Well Name: MUY WAYNO 18-7 FED COM	Well Location: T25S / R30E / SEC 18 / LOT 3 / 32.126774 / -103.925153	County or Parish/State: EDDY / NM
Well Number: 401H	Type of Well: OIL WELL	Allottee or Tribe Name:
Lease Number: NMNM120898	Unit or CA Name:	Unit or CA Number:
US Well Number:	Operator: XTO PERMIAN OPERATING LLC

Type of Submission: Notice of Intent

Type of Action: APD Change

Procedure Description: XTO Permian Operating, LLC. respectfully requests approval to make the following changes to the approved APD. Changes include SHL, KOP, FTP, proposed total depth, pool, and Dedicated Acreage. FROM: TO: SHL: 1436' FSL & 1315' FWL OF SECTION 18-T25S-30E 1626' FSL & 1315' FWL OF SECTION 18-T25S-30E KOP: 2044' FSL & 334 FWL OF SECTION 18-T25S-30E 1382' FSL & 383' FWL OF SECTION 18-T25S-30E FTP: 2560' FNL & 335' FWL OF SECTION 18-T25S-R30E 2560' FNL & 204' FWL OF SECTION 18-T25E-30E The proposed total depth is changing FROM 17689' MD; 9268' TVD TO 18387' MD; 9266' TVD. Pool code is changing FROM: Pierce Crossing; Bone Spring, East (96473) TO Corral Canyon; Bone Spring, South (13354) Dedicated Acreage is changing FROM 243.44 Acres TO 483.44 Acres. There is no new surface disturbance.

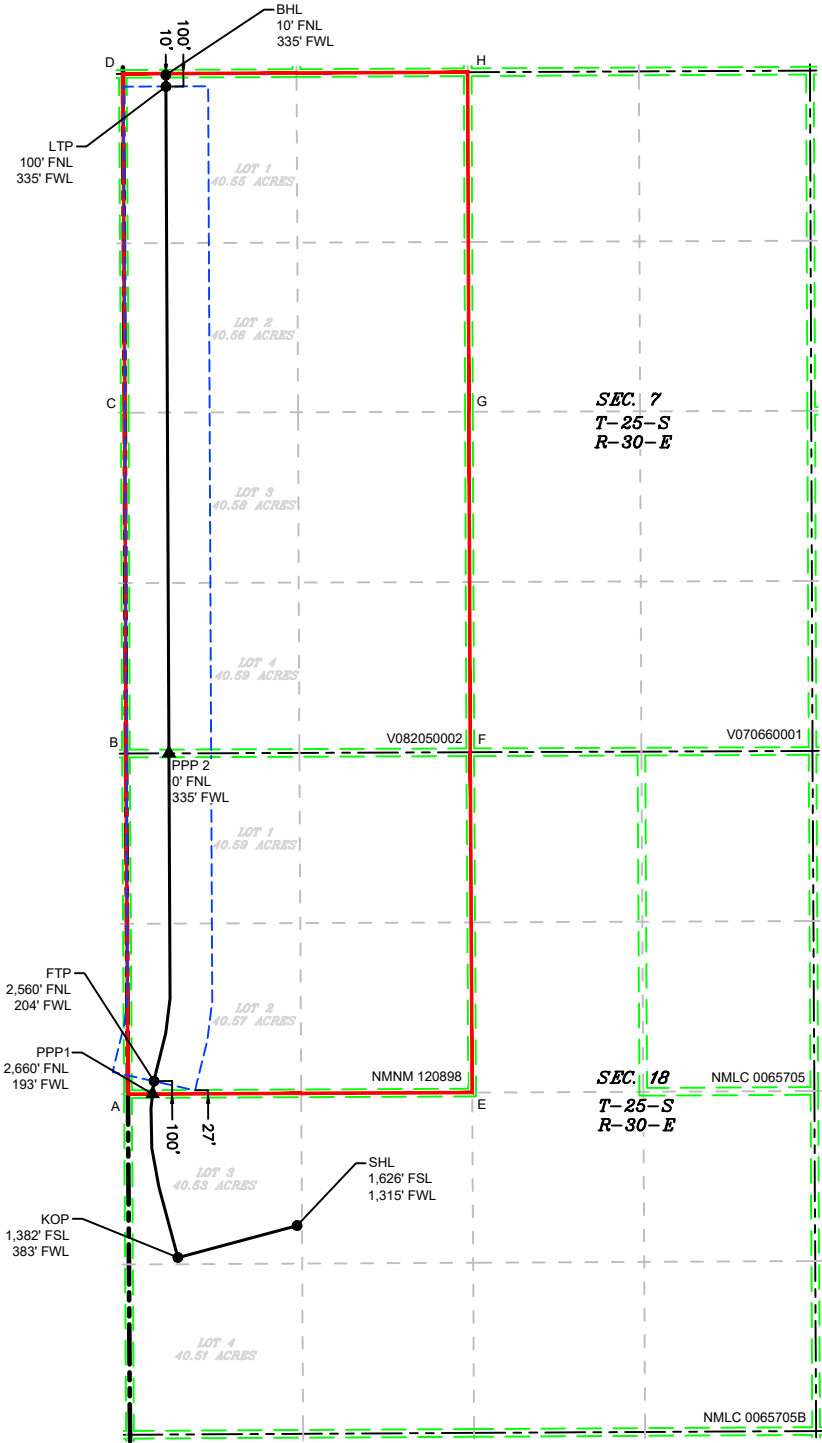
Pool code is changing FROM: Pierce Crossing; Bone Spring, East (96473) TO Corral Canyon; Bone Spring, South (13354)

Dedicated Acreage is changing FROM 243.44 Acres TO 483.44 Acres.

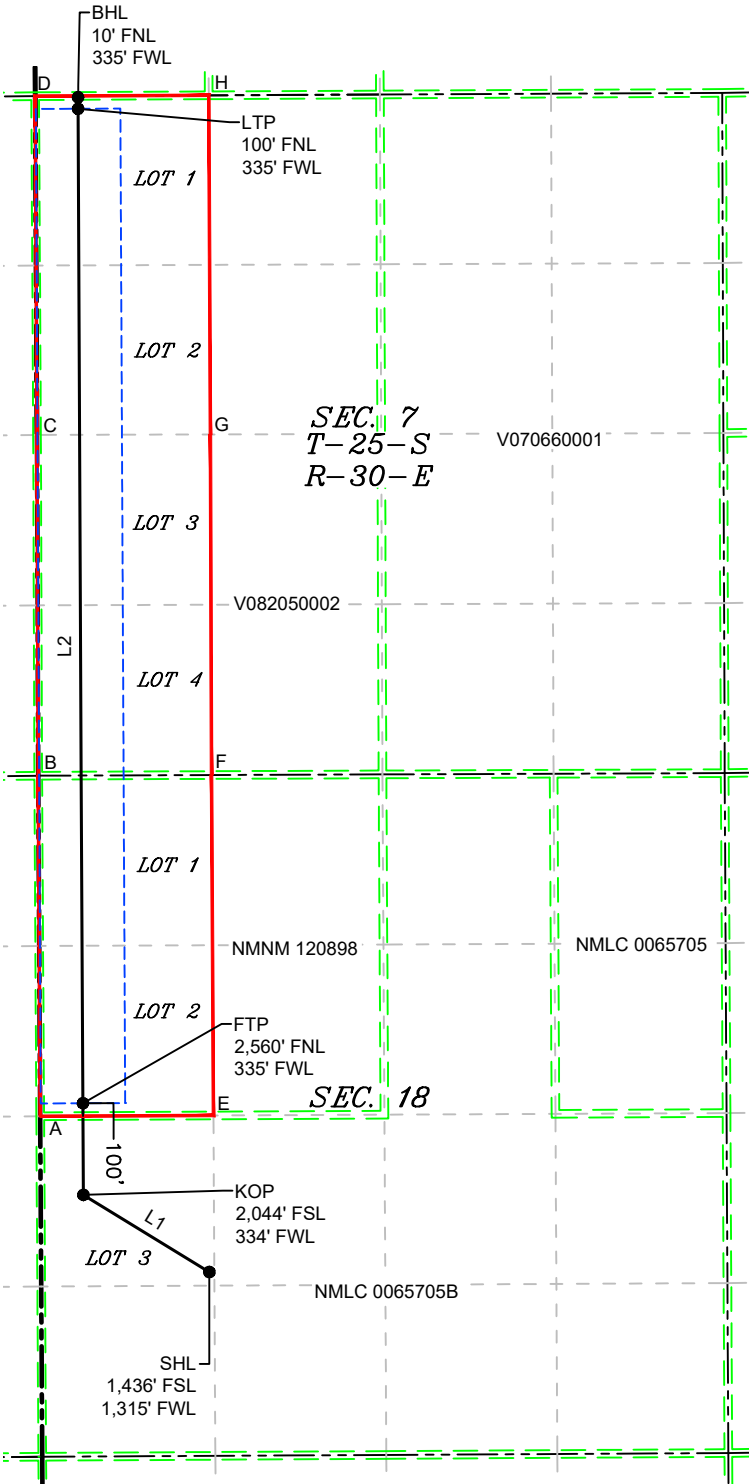
XTO Permian Operating, LLC. respectfully requests approval to change the name of this well from "MUY WAYNO 18 FEDERAL 401H" to "MUY WAYNO 18-7 FED COM 401H".
